### ADDENDUM NO. 3

Date Issued: October 11, 2024

<b>PROJECT NUMBER:</b>	10-19202-00
<b>PROJECT NAME:</b>	Jennings Community Center
<b>CLIENT NAME:</b>	City of Jennings
<b>PREPARED BY:</b>	KAI Design 2060 Craigshire Dr, St. Louis, MO 63146

### 9 DATA OUTLET DETAILS

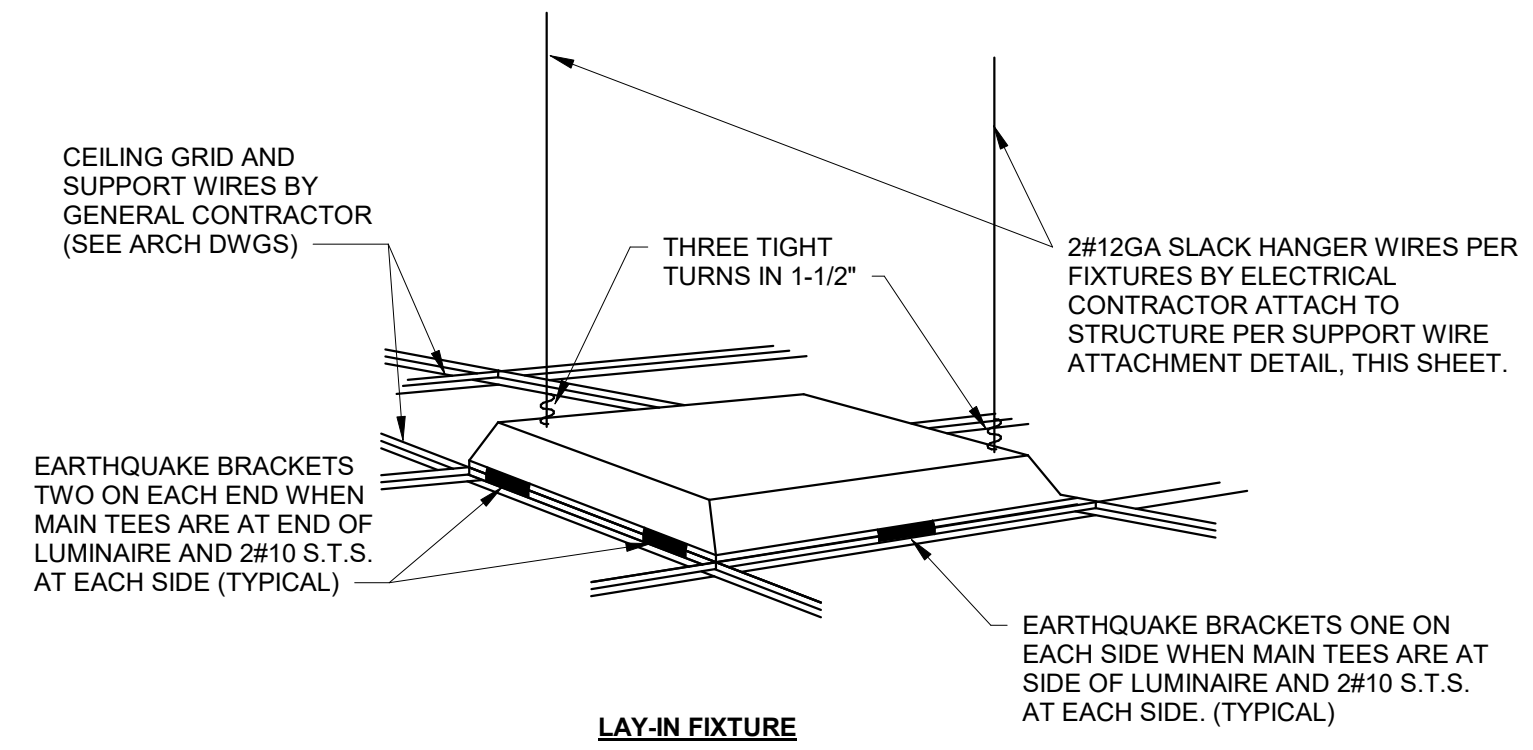
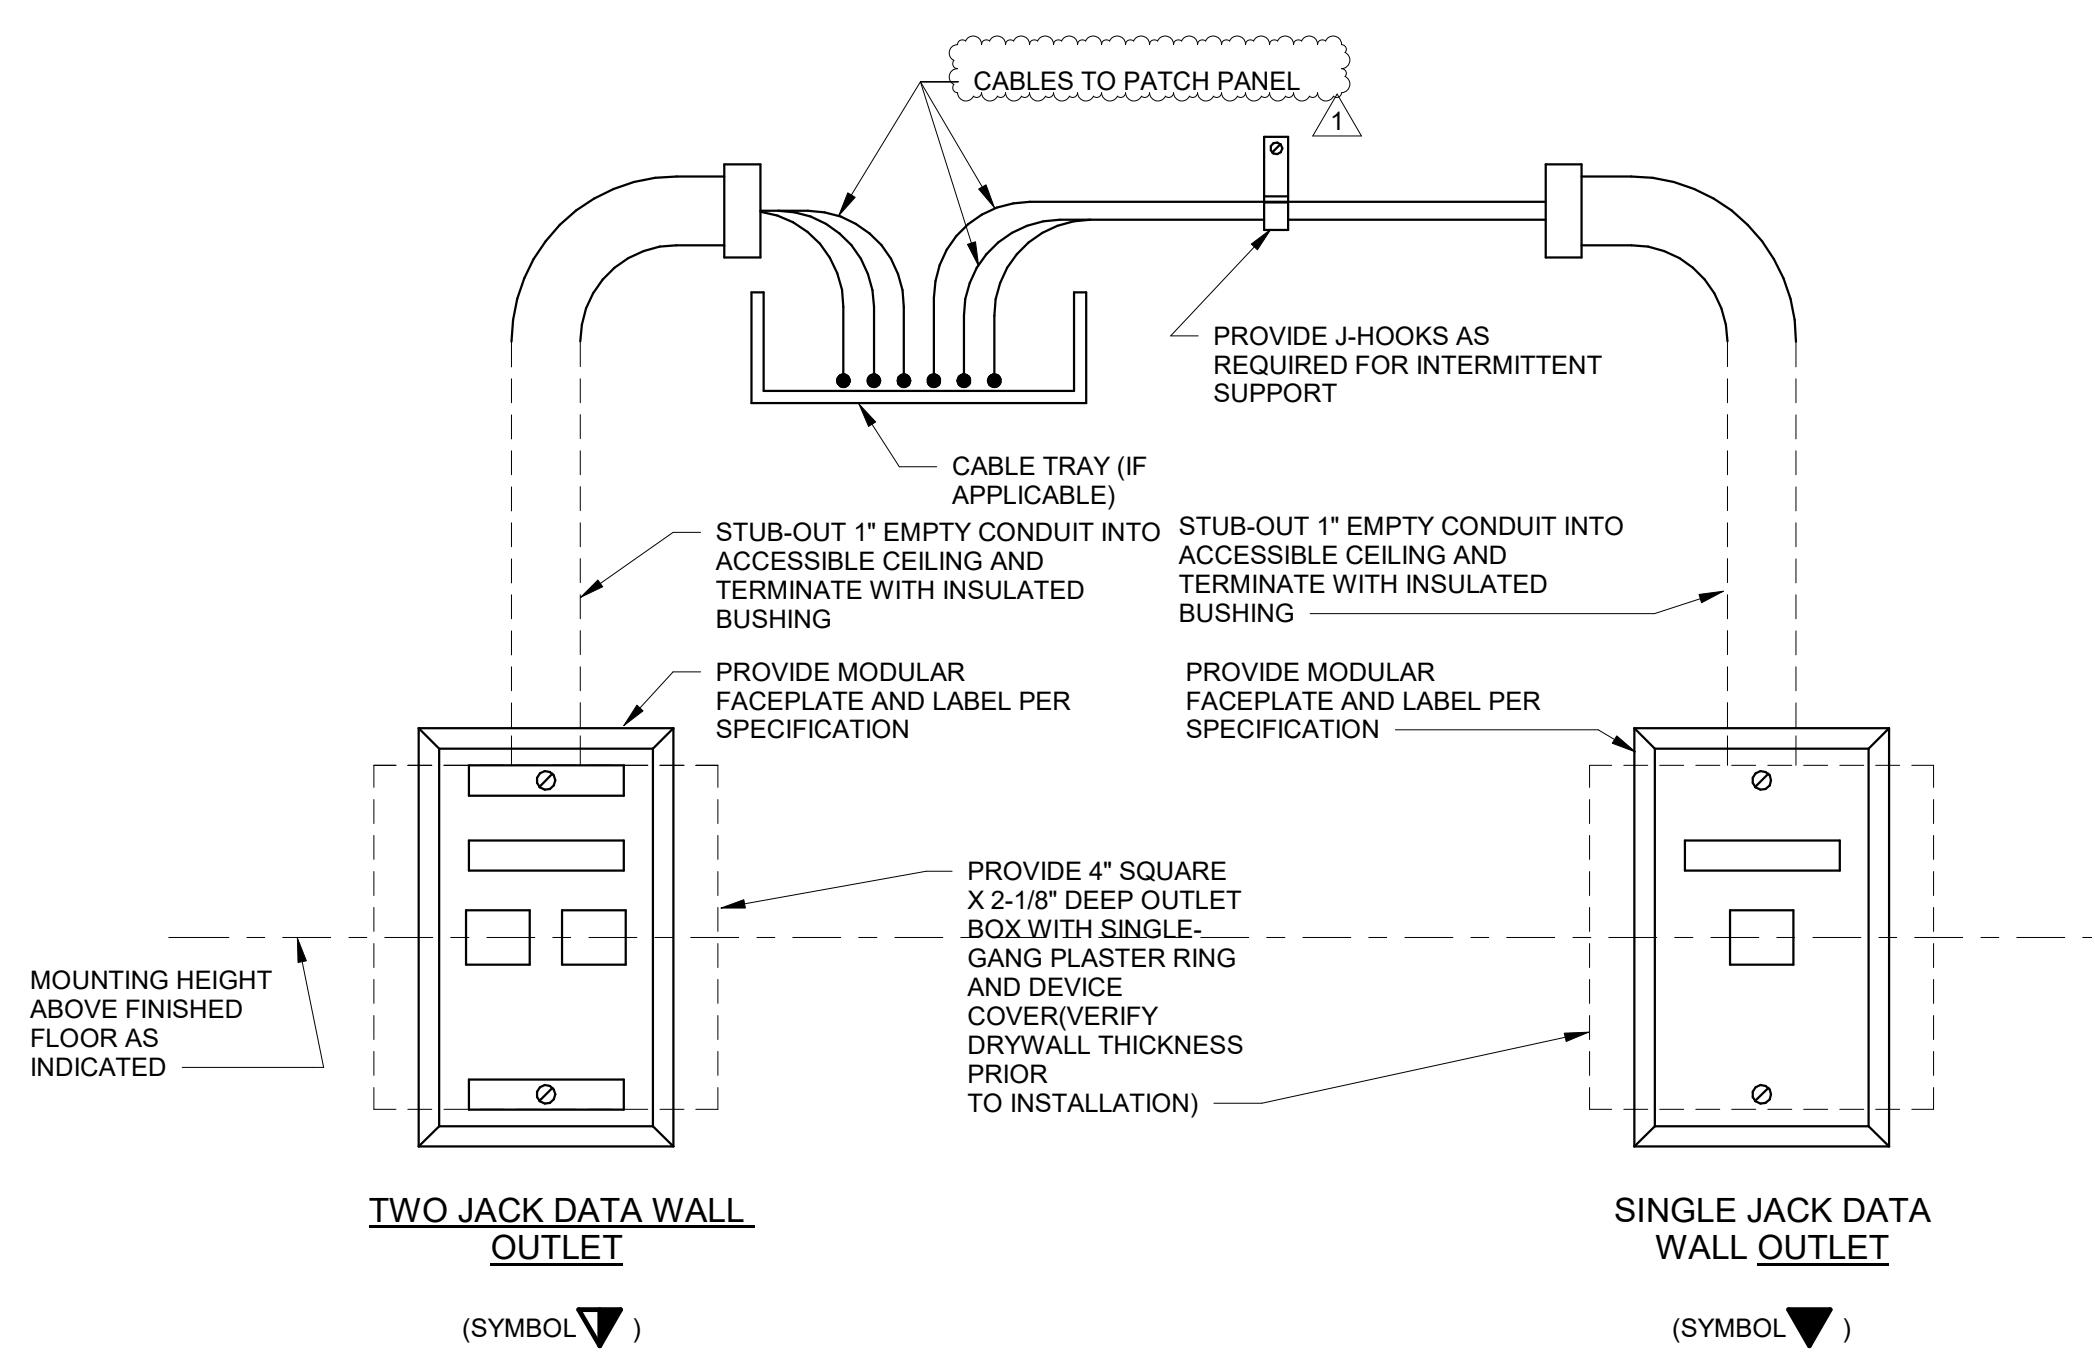
013	Drawing E20, Note 1 states to install cabling for cameras. E501, detail 1 states to provide cabling for WAP's. However, E501, Detail 9 states "Cables to patch panel (by others)." Please ask for clarification on the cabling scope.	Contractor is to furnish and install the cabling for cameras, WAPs, data outlets.	3
014	Drawing E Details 2 & 6 states to provide Cat 5 cable. This is certainly a mistake so please ask for clarification on the cable type/specification.	Use Cat 6 cable.	3
015	Who will be responsible for providing and installing the Access Control head end?	The Owner and their supplier will provide and install the Access Control devices	3
016	Who will be responsible for providing and installing the Access Control door devices?	The Owner and their supplier will provide and install the Access Control devices	3
017	Will a P8 pilaster be needed at the interior column pads on column line CCD? The top of footing on detail 6/S300 shows 99'-0" and the top of the P8 pilaster shows 99'-0".	Yes, a pilaster is required. The top of all footings = 96'- 6" per Foundation Plan Note 3 on S-200. Therefore T/P8 = 99'- 0" and bottom of P8 = T/Ftg = 96'- 6". At CCD-CC4 and CCD-CC5, the P8 pilaster will be placed monolithic with the Grade Beam detailed on 6/S-300.	3

SHEET NO.  
**E701**  
Copyright © 2021 KAI Design, LLC  
All Rights Reserved

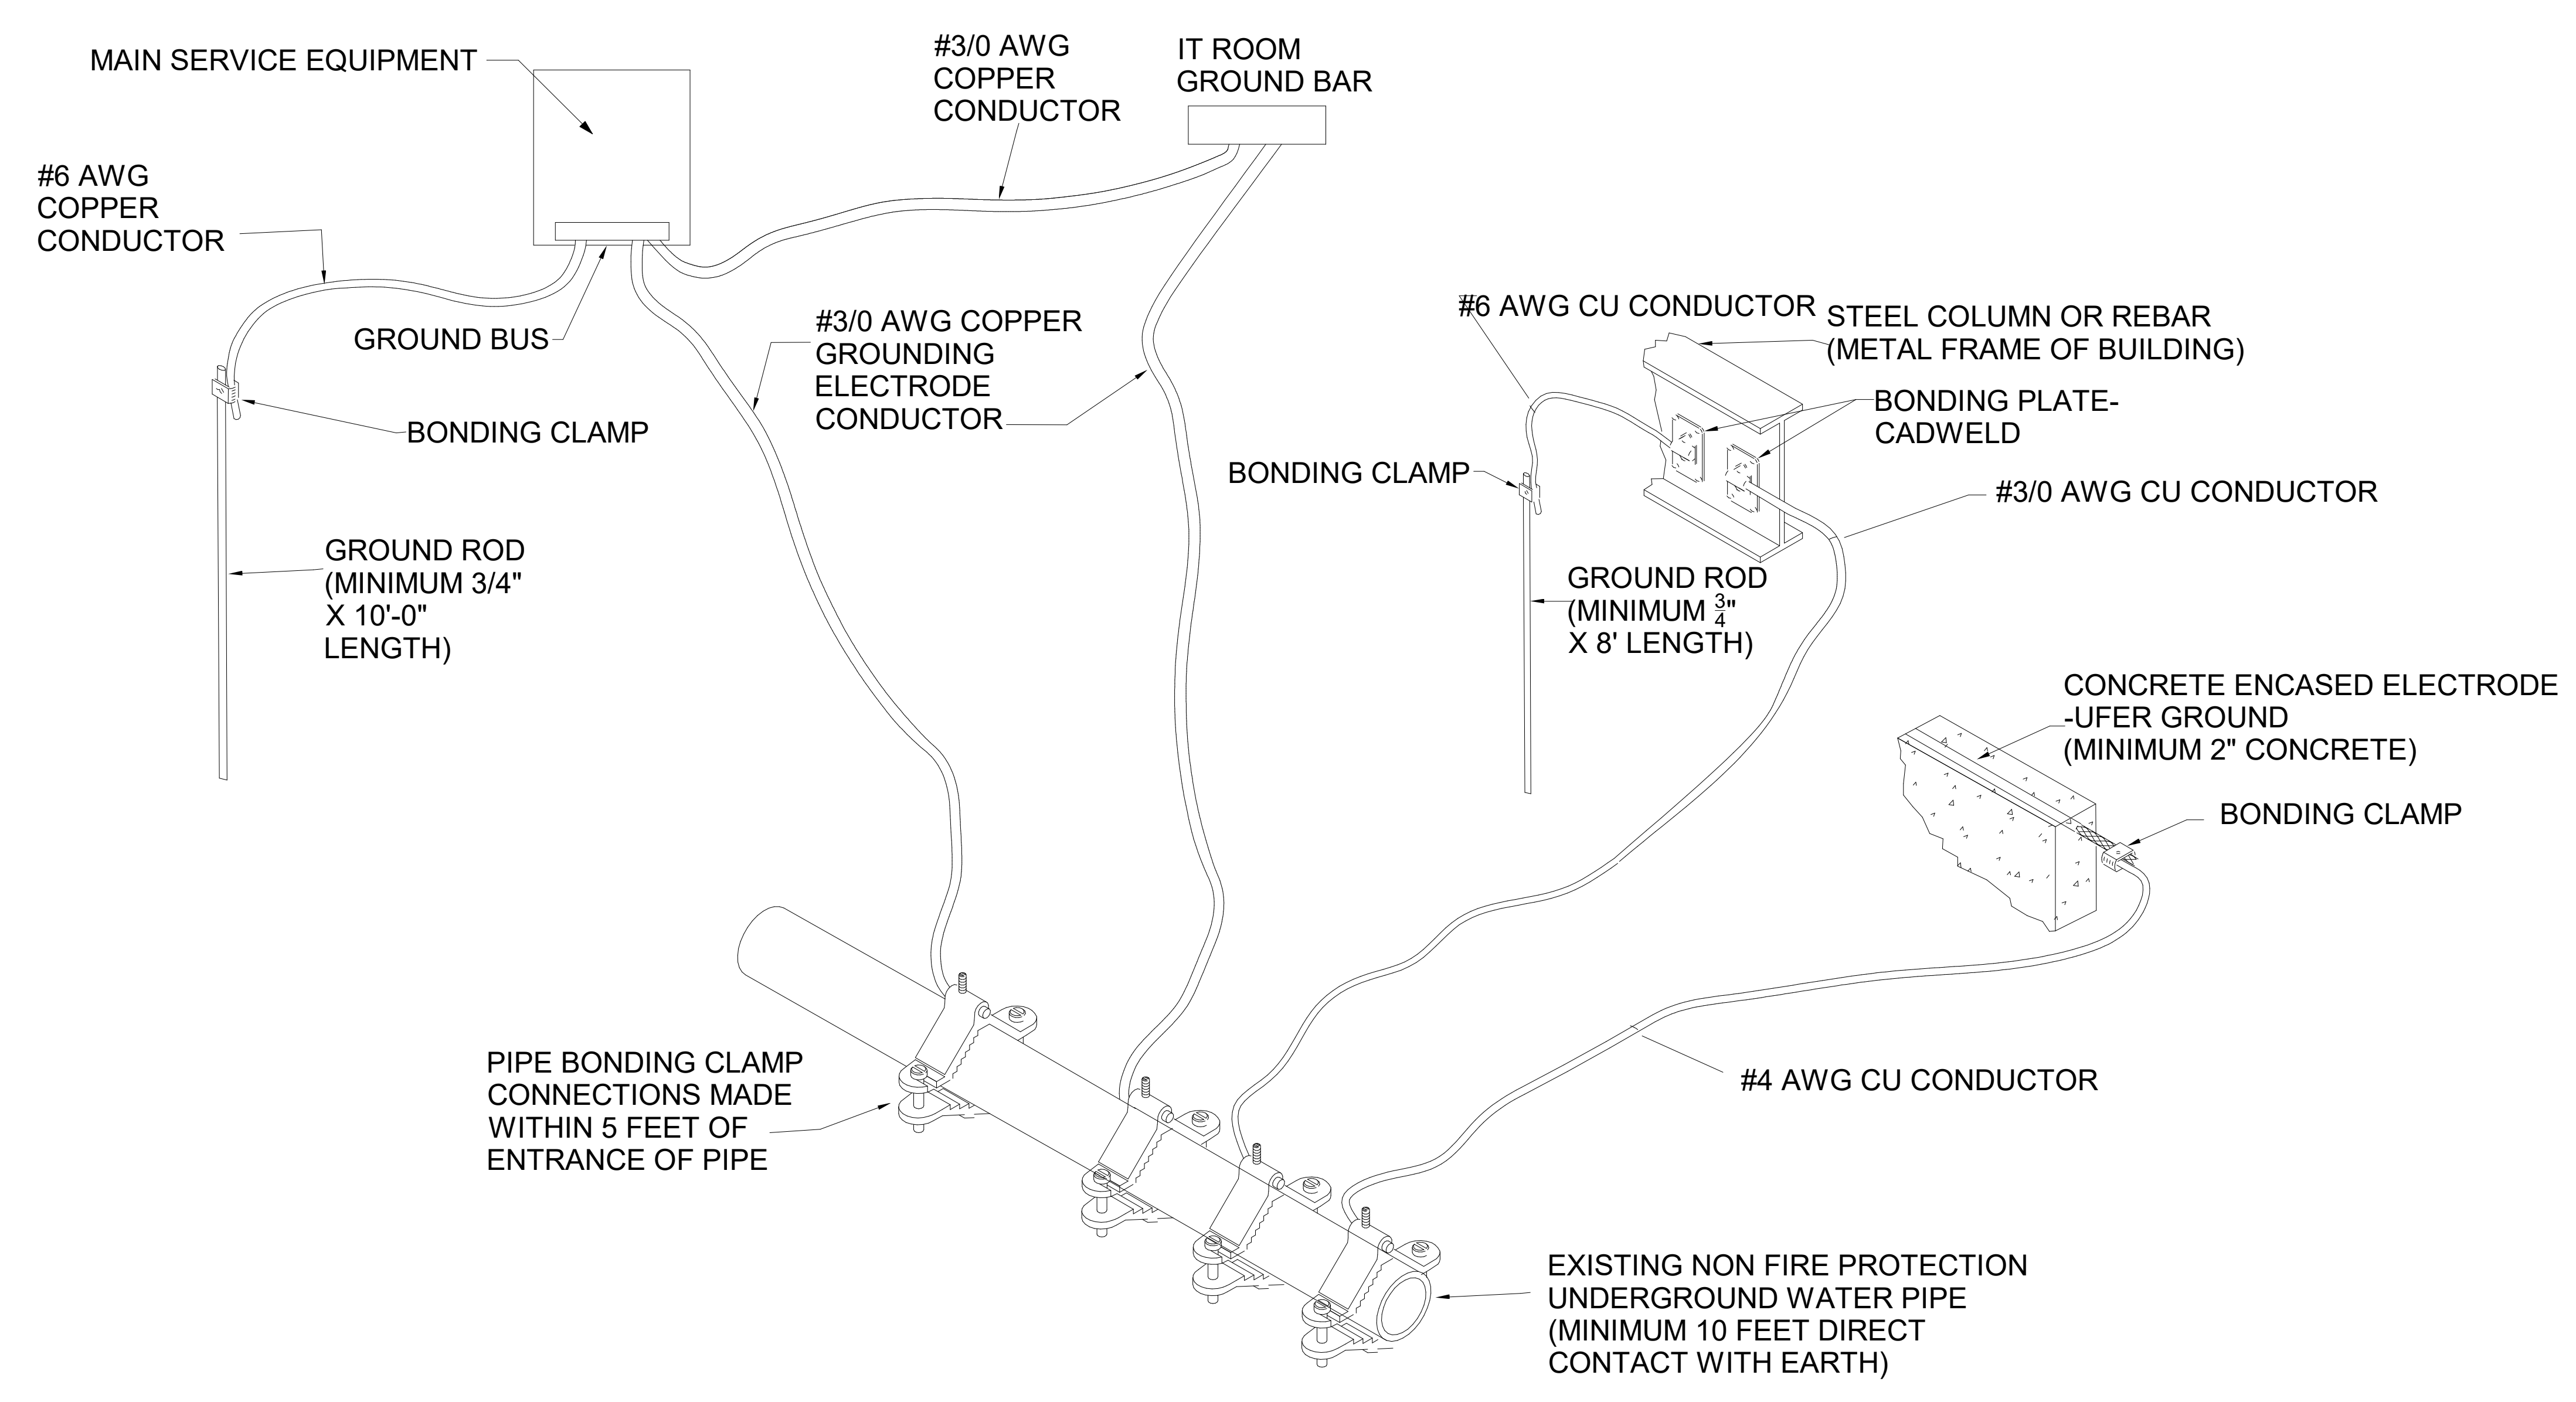
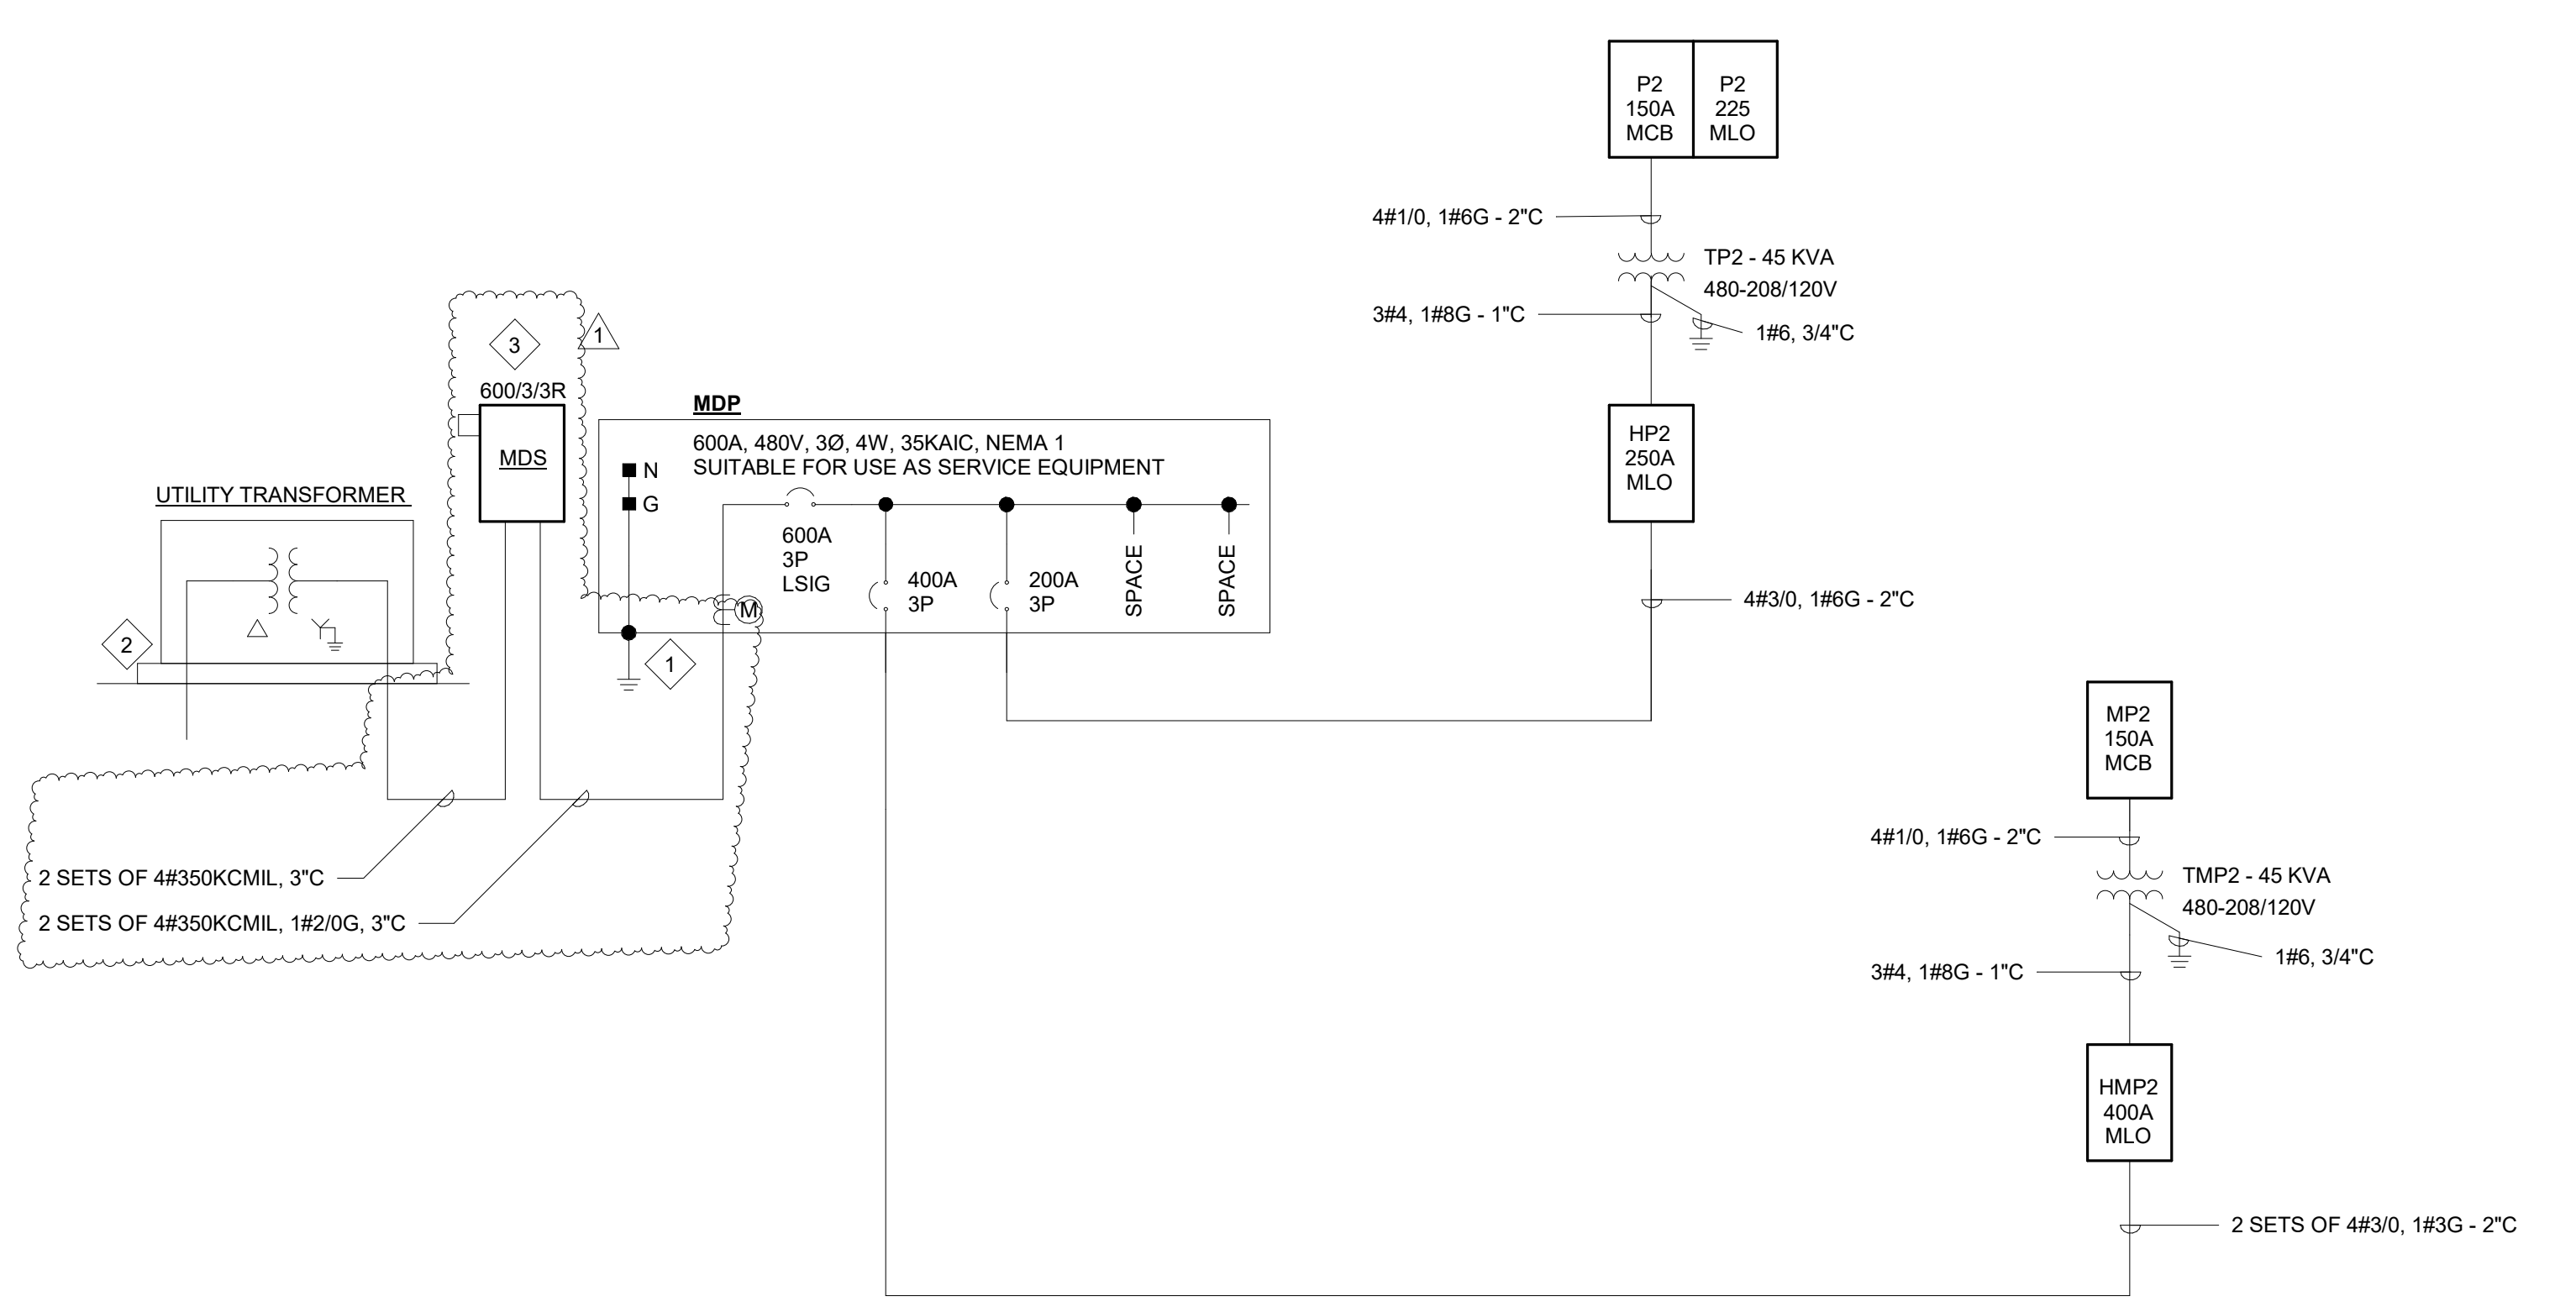
SHEET #	DESCRIPTION OF CHANGES
E001	Deleted symbols for receptacles on emergency power from the Legend.
E101	Revised design for utility power equipment and feeders per AMEREN's requirements.
E201	Revised all receptacles indicated as emergency to standard symbols. Added 20A, 120V circuit for access control system panel in IT room 214. Added one general purpose receptacle and fed receptacles from circuit P2-19 in Mechanical Room 222.
E501	Revised Detail 9 to include cables for data outlets in scope. Replaced CAT 5 cable with CAT 6 cable in Details 2 and 6.
E604	Added 20A, 120V circuit for access control system panel in panel P2.
E701	Added exterior disconnect switch and meter box per AMEREN's requirements.
